N00221_000695
MARE ISLAND
SSIC NO. 5090.3.A

June 15, 2005

Subject: California Geological Services Unit Memorandum of April 25, 2005, on Mare Island Investigation Area H1 proposed monitoring well locations

FIGURE 1

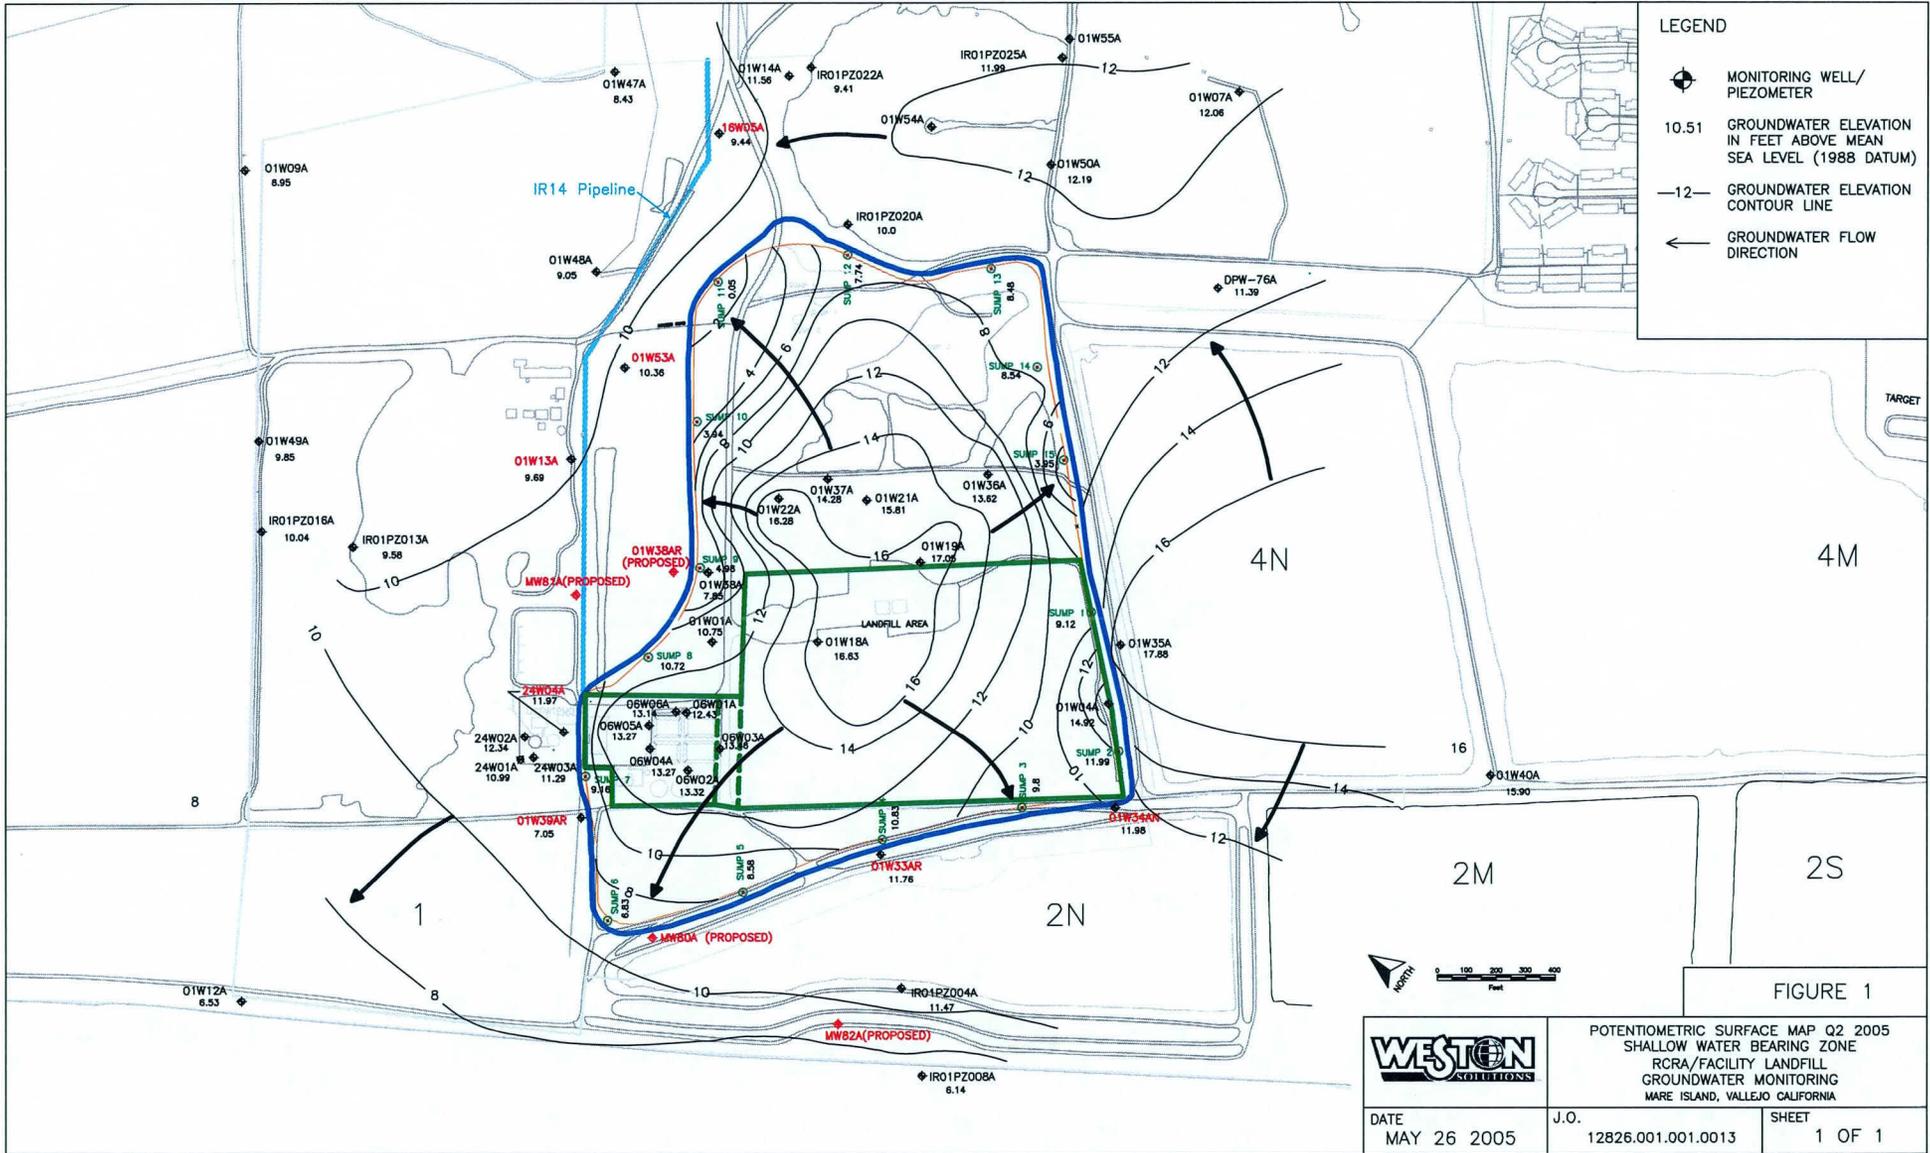
1. The extraction trench and the pump system currently control the groundwater levels and flow directions inside the slurry wall. Figure 1 shows a SWBZ potentiometric surface map and groundwater flow directions as determined in the second quarter of 2005. Notably, the highest point of the groundwater mound in the RCRA Landfill has moved from the southwestern corner of the Landfill (well 01W4A) to the northeastern quadrant of the Landfill (well 01W18A). Figure 1 shows that the radial flow from the Landfill

groundwater mound is completely contained within the slurry wall and controlled by the extraction trench.

Under the current hydrological conditions, the regional SWBZ groundwater flow direction defines the placement of the IPOC wells. If the slurry wall is the IPOC, then the hydraulically downgradient limit of the IPOC would be located on the western and northern sides of the Containment Area. Wells 01W34AN, 01W33AR, MW80A (proposed), 01W39AR, 01W38AR (proposed), and 24W04A shown in Figure 1 intersect this limit and thus would be the appropriate IPOC wells.

- a. Wells 01W36A and 01W37A will be decommissioned as recommended by GSU. However, well 01W18A, previously proposed for abandonment, will be saved and used as a water level monitoring well. This well is in the area of the maximum groundwater elevation within the slurry wall as shown in Figure 1 and is critical for accurate groundwater flow direction evaluation. Preservation of this well will be incorporated into the overall cap design. Well 01W4A, the former highest point of groundwater elevation within the mound, may be abandoned.
- b. The groundwater elevation monitoring wells PZ30A and PZ301A inside the slurry wall will be installed in coordination with the cap construction activity.
- c. Wells 01W36B and 01W37B will be decommissioned as recommended by GSU.
- d. Wells 01W36C and 01W37C will be decommissioned as recommended by GSU.

FIGURE 2

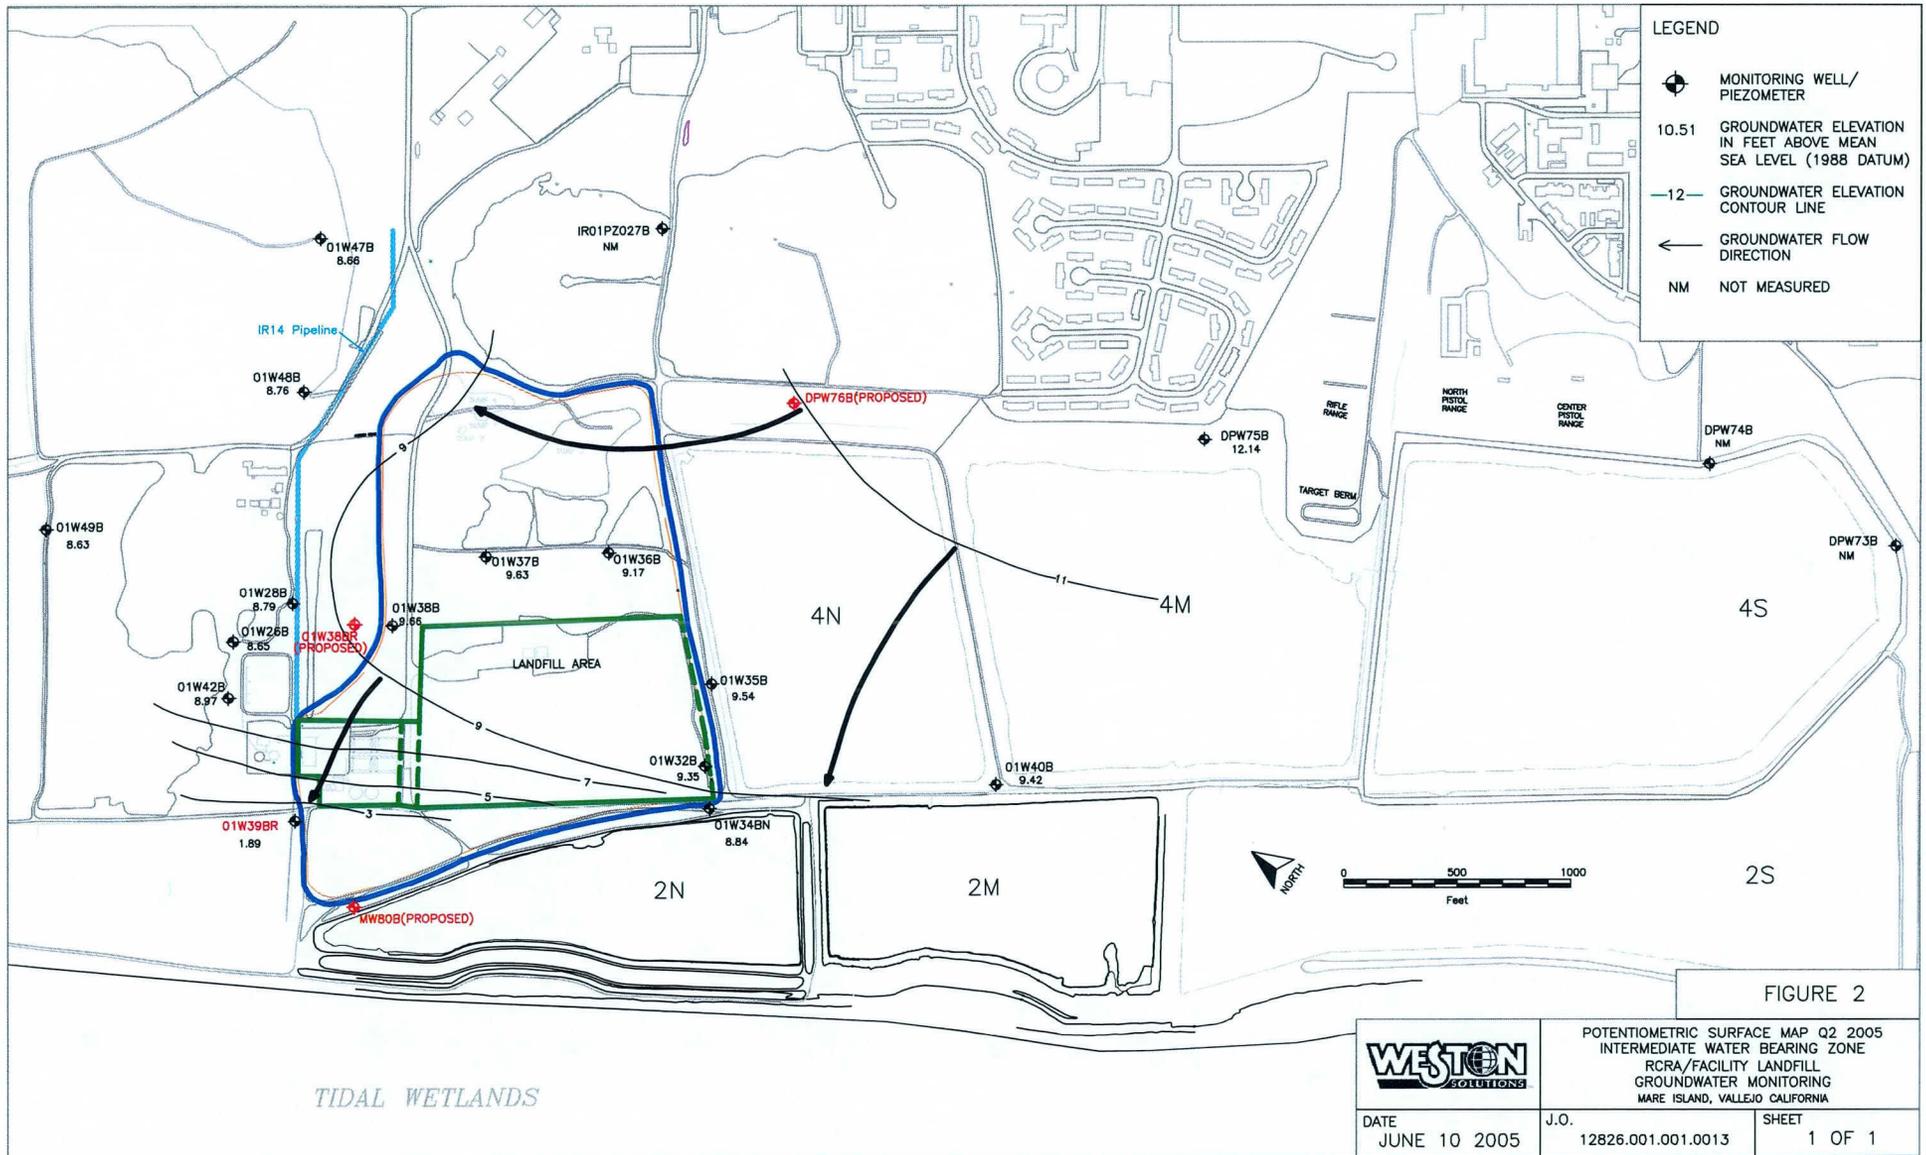
In the intermediate water-bearing zone (IWBZ), the groundwater flow is regional and unaffected by interim remediation activities, other than from a beneficial reduction in the vertical hydraulic gradient due to the extraction of SWBZ groundwater within the Containment Area. Figure 2 shows that the IWBZ groundwater flows in the western and northwestern directions. There is no technical or regulatory basis for placing upgradient IPOC wells as recommended by GSU. It has been agreed in previous discussions and communications with DTSC that the IPOC wells are downgradient wells as defined by Title 22 Article 6. The following downgradient wells are appropriate for the IWBZ POC/IPOC wells: 01W34BN, MW80B (proposed), 01W39BR, and 01W38BR (proposed).
